Flight Procedures Cover Page	Task Action: FLIGHT CHECK	Task Type: SID	Estimated Chart Date: 07/09/2026	APWS Task ID: A32E10EBE0634135A3597E76DB2E079C	APWS Project ID: 62D611A85B424920B4988C966C827416
Procedure: PORTLAND SEVEN DEPARTURE (SID)		Enroute: YES	Specialist: Tuttle, Judith		Agreement Number:
Airport ID: KPWM			Airport City: PORTLAND		State: ME
Facility ID:	Facility Type:	Flight Inspection Remark Type: New FC Slot			
Procedure Comments: ACTIVE AIRPORT DATA USED. UPDATED TAKEOFF MINIMUMS. 2 EA WAIVERS: (1) FOR AN ATC REQUESTED MAINTAINED ALTITUDE LOWER THAN THE UNRESTRICTED CLIMB ALLOWED BY TERPS EVALUATION. (1) FOR USING LESS ROC THAN REQUIRED FOR DP LEVEL OCS. CONTACT: RAKE MCGRAW (AJV-A422), 405.954.8711. QUALITY 41 CHECKED QUALITY 42 CHECKED

Portland, ME: PORTLAND INTL JETPORT (KPWM)

PORTLAND SEVEN DEPARTURE

PORTLAND SIX DEPARTURE

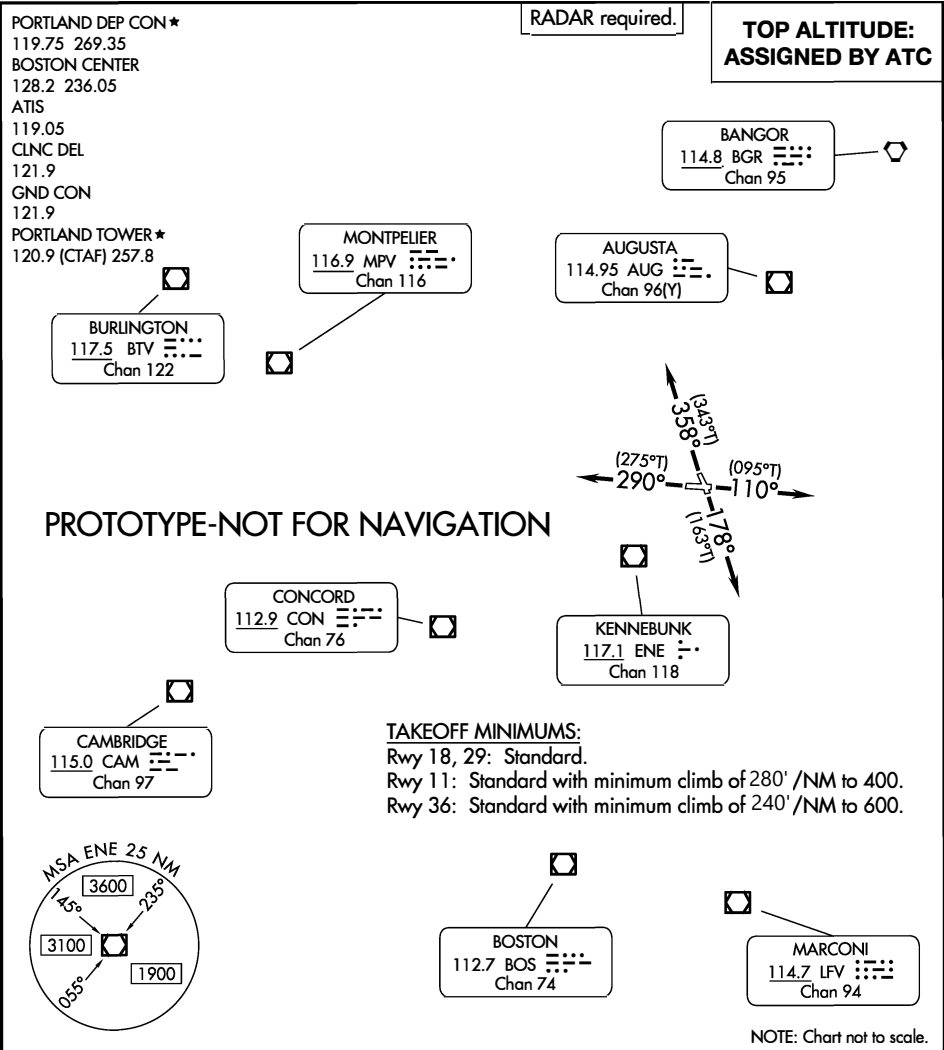
TAKEOFF RUNWAY 11: Climb heading 110° for vectors to assigned route/NAVAID/fix.
Maintain ATC assigned altitude. Expect filed altitude 5 minutes after departure.

TAKEOFF RUNWAY 18: Climb heading 178° for vectors to assigned route/NAVAID/fix.
Maintain ATC assigned altitude. Expect filed altitude 5 minutes after departure.

TAKEOFF RUNWAY 29: Climb heading 290° for vectors to assigned route/NAVAID/fix.
Maintain ATC assigned altitude. Expect filed altitude 5 minutes after departure.

TAKEOFF RUNWAY 36: Climb heading 358° for vectors to assigned route/NAVAID/fix.
Maintain ATC assigned altitude. Expect filed altitude 5 minutes after departure.
